UNITED STATES PATENT AND TRADEMARK OFFICE

APPLICATION NO.	FILING DATE	FIRST NAMED INVENTOR	ATTORNEY DOCKET NO.	CONFIRMATION NO.
09/913,977	08/20/2001	Stephen Proulx	MCA-449 PC/US	8230
29621	7590	12/23/2003	EXAMINER	
MYKROLIS CORPORATION			POPOVICS, ROBERT J	
129 CONCORD ROAD			ART UNIT	
BILLERICA, MA 01821-4600			PAPER NUMBER

Office Action Summary	Application No. 09/913,977	Applicant(s) PROULX ET AL.	
	Examiner Robert J. Popovics	Art Unit 1724

DETAILED ACTION

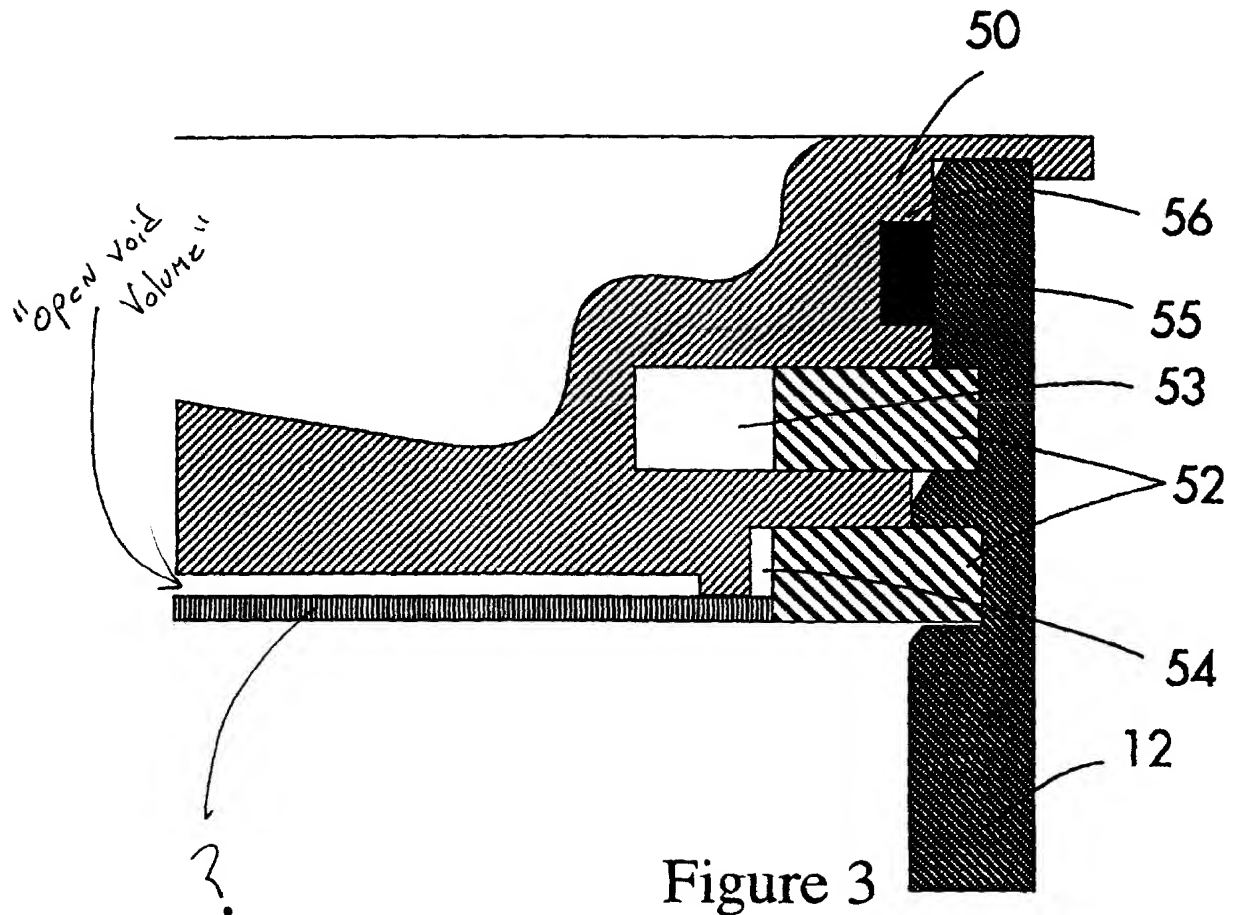
Claims **1-9** and **15-17** are rejected under 35 U.S.C. 112, first paragraph, as failing to comply with the enablement requirement. The claim(s) contains subject matter which was not described in the specification in such a way as to enable one skilled in the art to which it pertains, or with which it is most nearly connected, to make and/or use the invention. Below is Fig. 3 (the elected end cap species) taken from Applicant's specification.

Figure 3 appears to have an “open void volume” as indicated by the handwritten arrow, yet Applicant’s **“single generic concept is the provision of a depth filter free of an open void volume upstream of the depth filter in order to remove undesirably large particles from the filter being filtered.”** Since an open void volume appears to be clearly shown in the drawing, the disclosure is not commensurate with the scope of the claims, and does not enable one skilled in the art to practice the invention. Moreover, it is unclear what the unlabeled member beneath the open void volume, is (see arrow with question mark).

It is unclear what Applicant intends by the recitation **“being free of an open void volume upstream of the depth filter.”** The elected end cap species (Fig. 3) appears to show an open void volume upstream of the depth filter (see the enablement rejection above). Thus, it is unclear what Applicant means by this language in the context used. Furthermore, the “inlet” and the “outlet” appear to constitute “open void volumes.” It is unclear if Applicant’s claims intend to exclude these volumes from the “hollow housing” volume. As drafted, the claims are seen to include the open void volumes of the inlet and outlet, and thus, present an inconsistency in the claim language. It is unclear where Applicant intends the “hollow housing” volume to end, and the inlet and outlet volumes to begin. As drafted, the meaning of the claims is unclear, since the housing has an inlet, which appears to constitute “an open void volume,” when the claim specifically precludes an open void volume from being upstream of the depth filter.
